Planning Commission MEETING AGENDA

**PLANNING COMMISSION
 SUPPLEMENTAL ITEM**

SUBJECT: **Comprehensive Landscape Plan Review for 505
 Brookletts Avenue**

DATE: December 8th, 2025
TO: Ross Benincasa - Applicant
Cc: Rick Van Emburgh - Town Engineer
Aaron Goller - EUC
Lynn Thomas - The Town Planner
FROM: Sierra Clem - Engineering Department
SUBJECT: Easton Crossing - Landscape Plan for Planning Commission

L-102

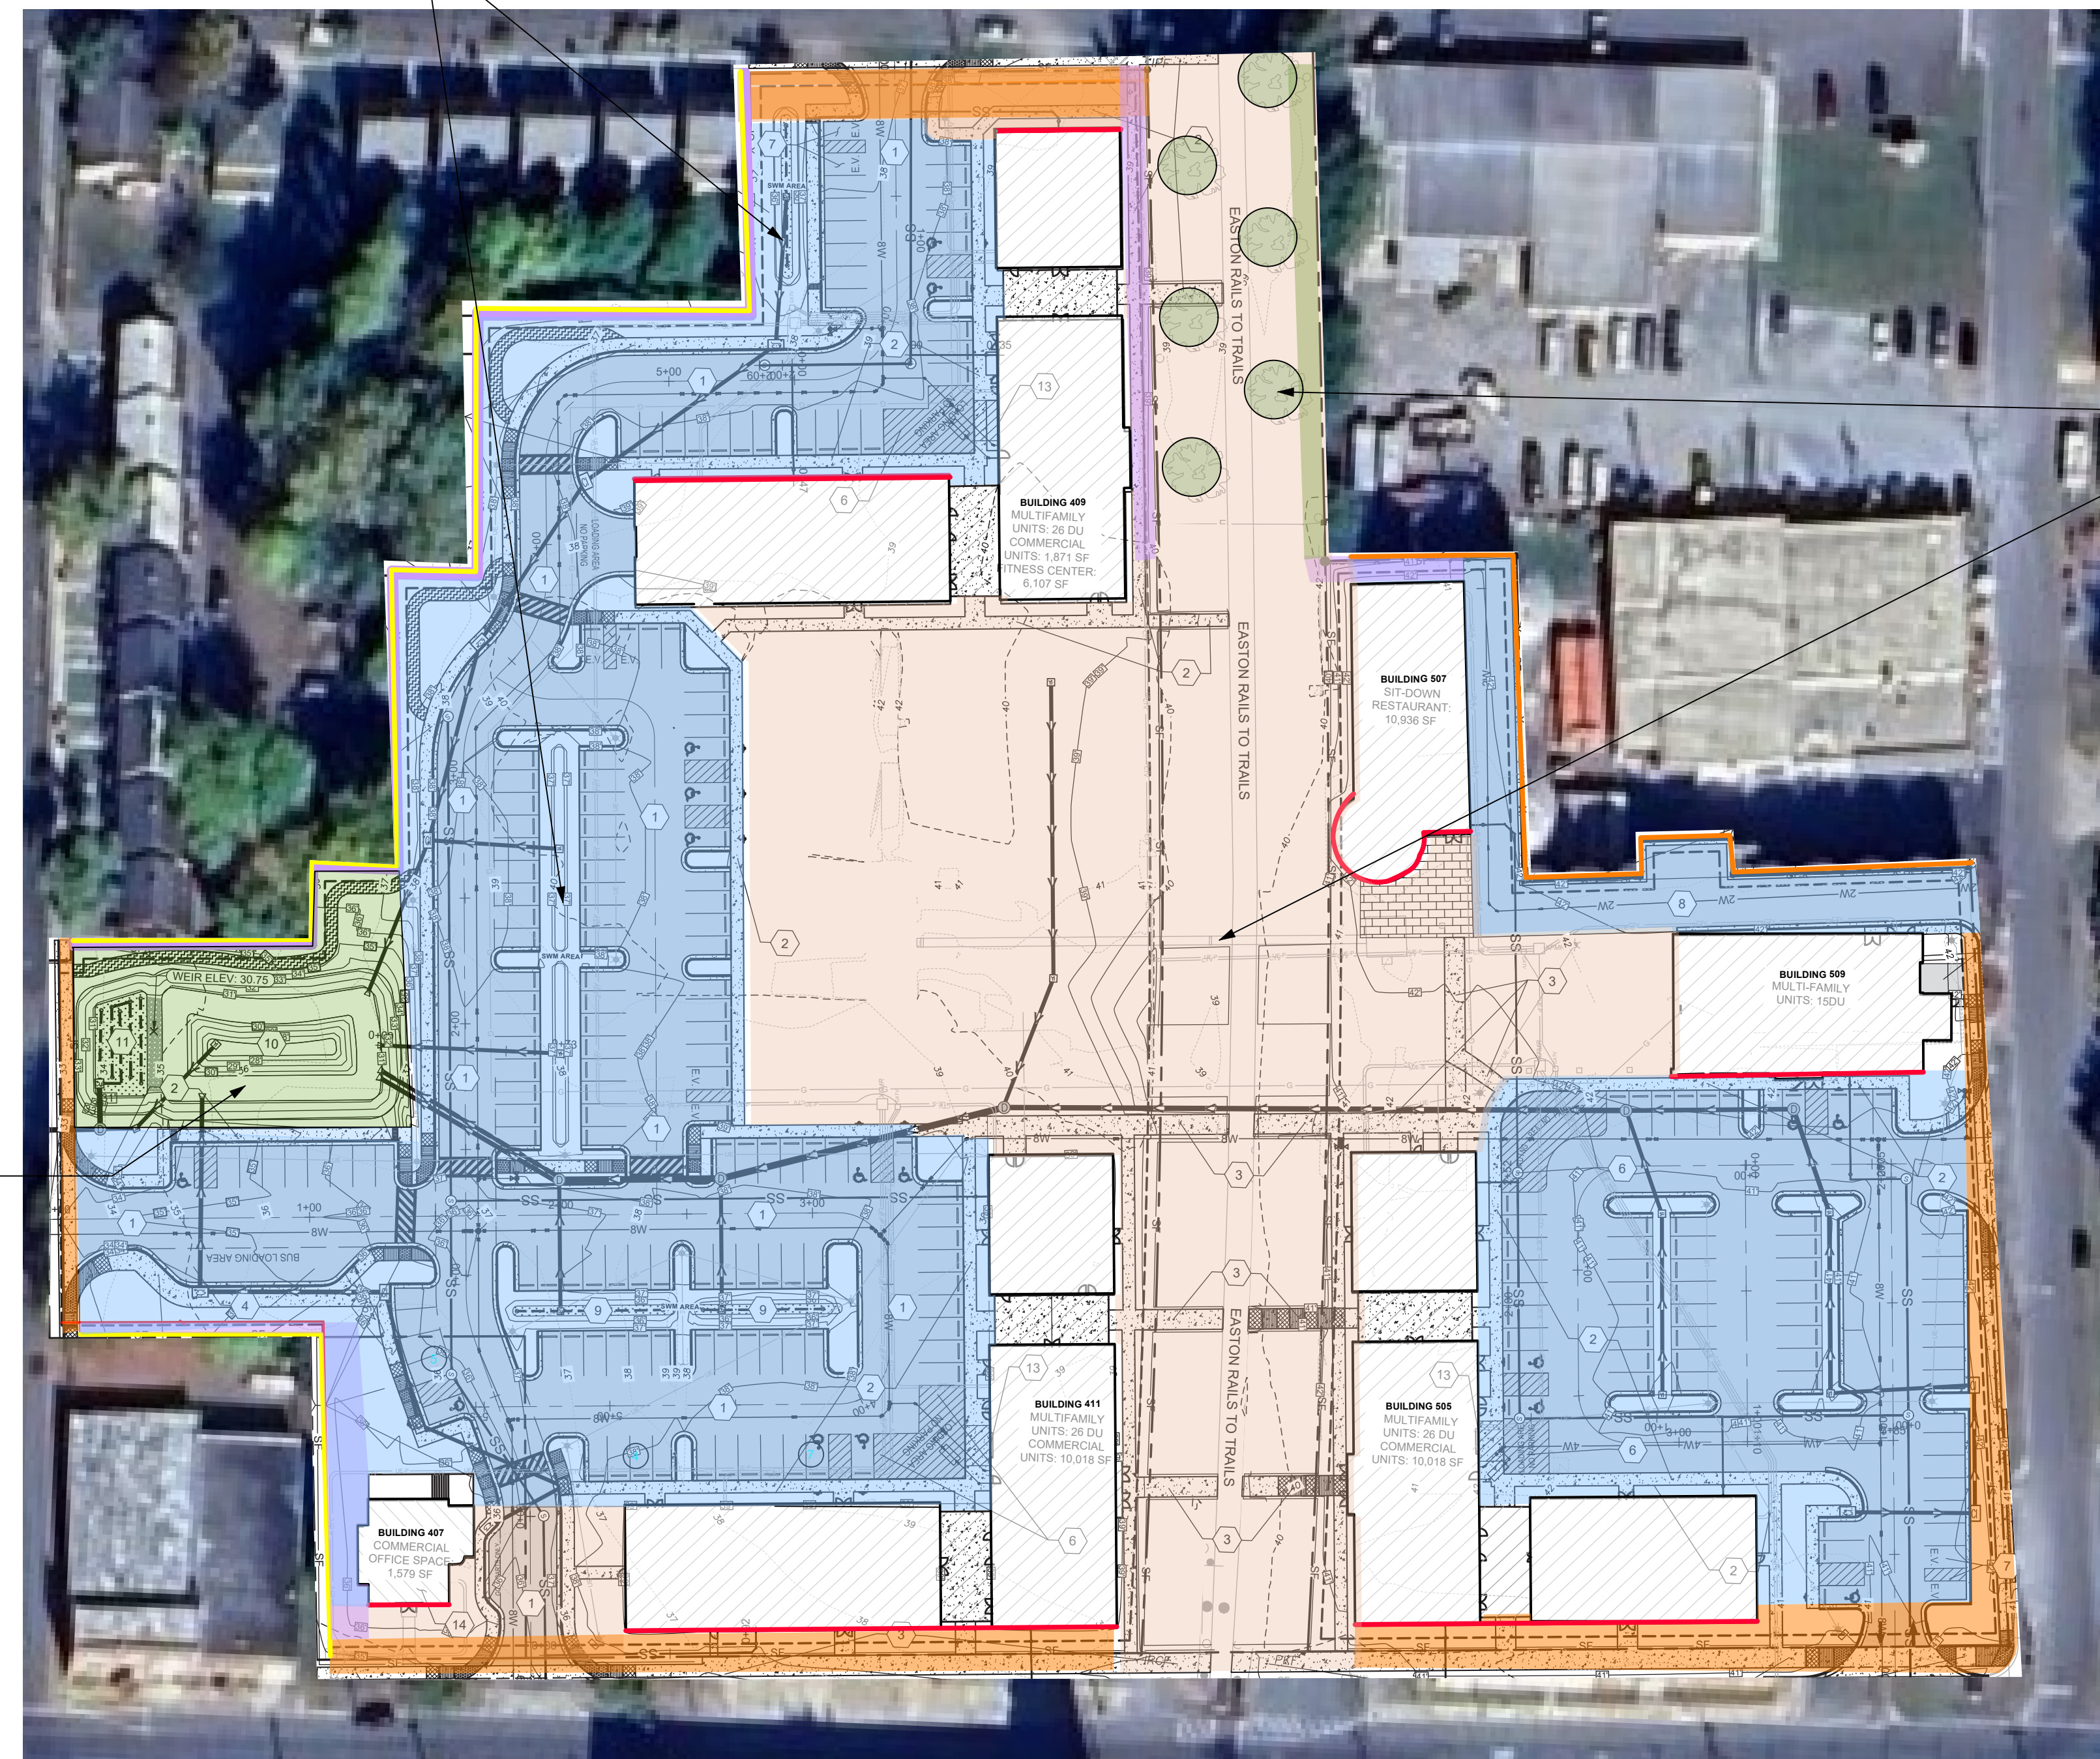
4. The Applicant shall submit a comprehensive landscaping plan that includes verification that the visibility triangles are clear of obstructions. **Analysis - *The applicant has provided a comprehensive landscape plan that is designed within the parameters of the approved landscape and buffering waivers from Chapter 28-1014.6.B.1(c), Chapter 28-1014.6.E.2(d), Chapter 28-1014.7.E.3(a) & (b) and Chapter 28-1014.7.E.5(a),(b) & (c) of the Zoning Code. The design includes landscaping elements that serve both aesthetic and functional purposes. Plant species suitable for stormwater management are incorporated into the parking lot islands. Along the edge of the stormwater management pond and the walking trail, additional landscaping has been provided. Furthermore, the interior of the parking lot features deciduous shade/canopy trees. The design for the open lawn incorporates canopy and understory trees, complemented by a variety of mixed low shrubs, perennials, and groundcover plantings. The yard also features bench seating in specific locations and flexible areas that can accommodate tables and chairs. The existing grain elevator, which functions as a sculptural structure, will be enhanced by a mix of low shrub, perennial, and grass meadow plantings. The existing Willow oaks located along the "Rails-to-Trails" will be preserved. The placement of visibility triangles at the intersections has demonstrated that the view is clear of obstruction, meeting the requirement per Town Standard R02.05.***

The overall landscape plan is supported by staff. The design effectively accentuates the open space and emphasizes the "Rails-to-Trails" amenity, which helps foster connectivity among the various neighborhoods and subdivisions. The placement of the visibility triangle clearly indicates an unobstructed view at the intersections. Following approval by the Planning Commission, a Landscape Plan, which must accompany the Development Site Plan, is required. This plan must clearly identify all proposed native plant species in both a plan view and a Landscape Legend. Given the numerous and complex phases of construction, a separate list of native plant species, along with a corresponding landscape cost estimate and surety, will be required for each phase. A Maryland State Landscape Architect is to sign and seal the Landscape Plan associated with the SWM Facility.

1. The applicant is to address all remaining Development Site Plan review comments.
2. A Landscape Plan is mandatory and must be submitted with the Development Site Plan. This plan requires both a plan view and a Landscape Legend clearly identifying all proposed native plant species. Due to the project's numerous and complex construction phases, each phase must have a separate list of native plant species, along with its corresponding landscape cost estimate and surety. Additionally, a Maryland State Landscape Architect must sign and seal the Landscape Plan specifically related to the Stormwater Management (SWM) Facility.
